Remarks

Serial No.: 09/943,968

Docket No.: 2269-4720US

Fig. 9

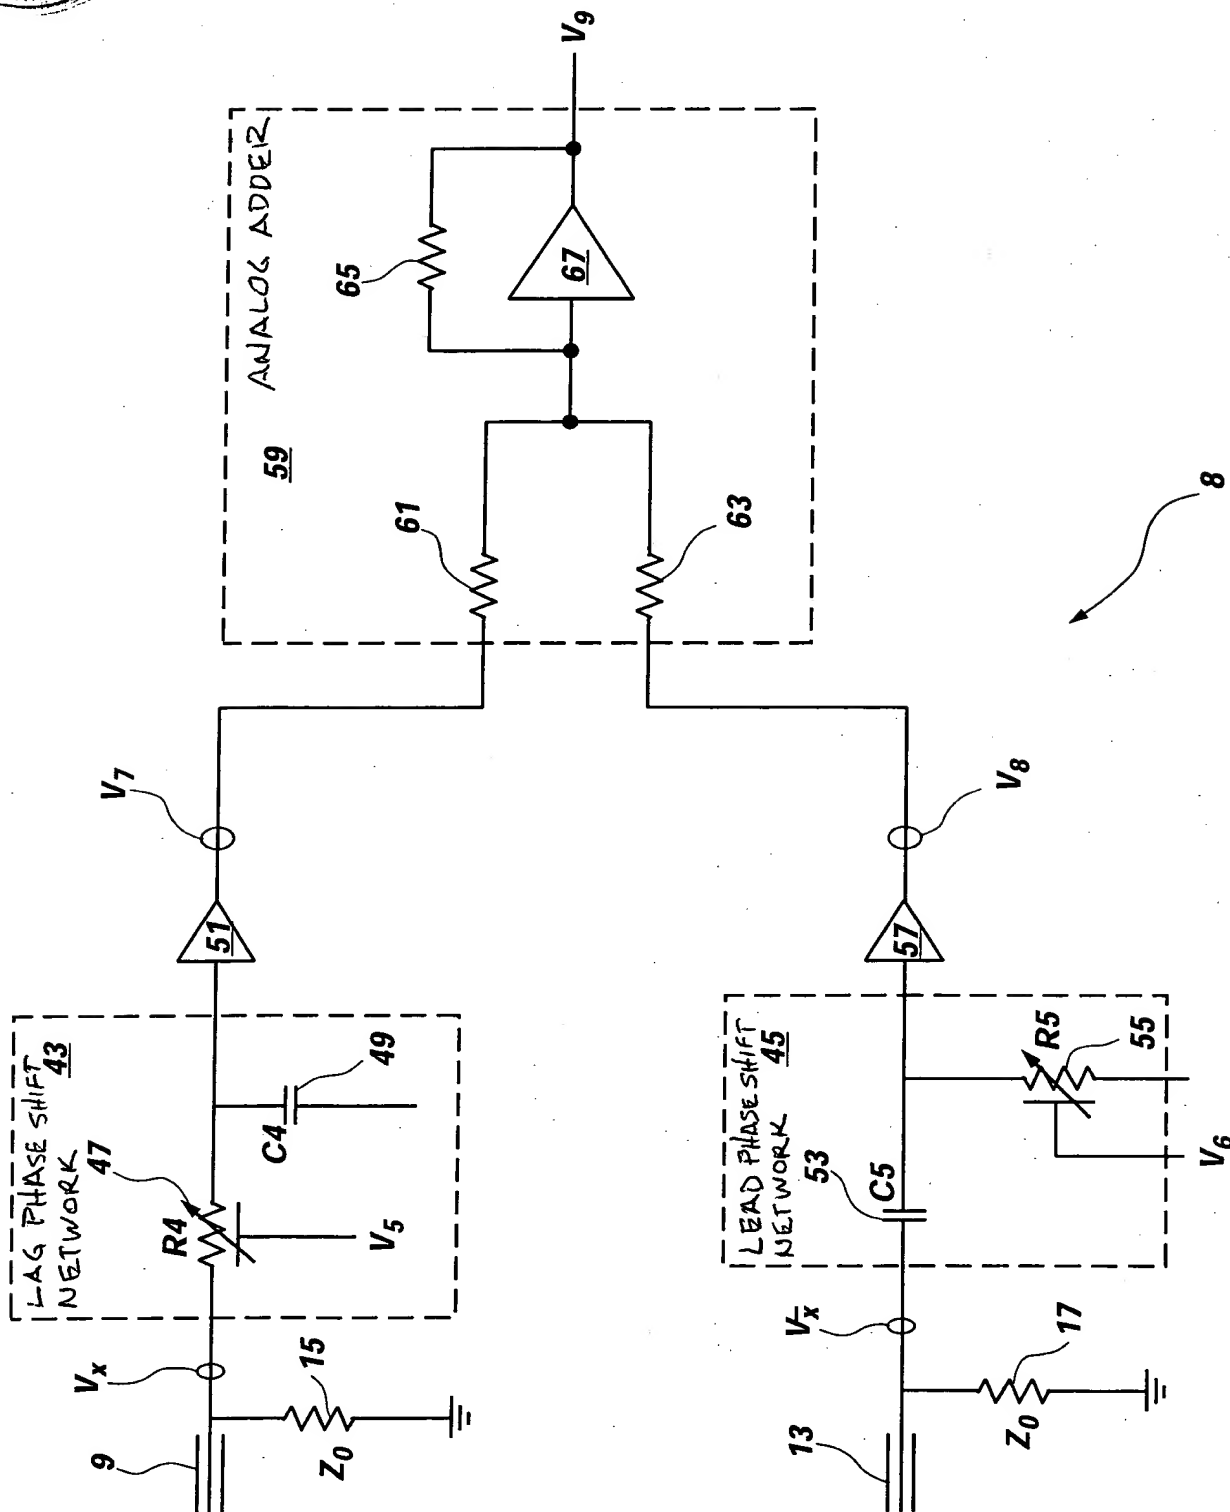
The attached replacement drawing sheet includes changes to FIG. 9. FIG. 9 has been amended to include a descriptive label for block elements 43, 45, and 59, as requested by the Examiner. Also attached, for the Examiner's convenience, is an annotated drawing sheet showing the changes incorporated into the replacement drawing sheet.
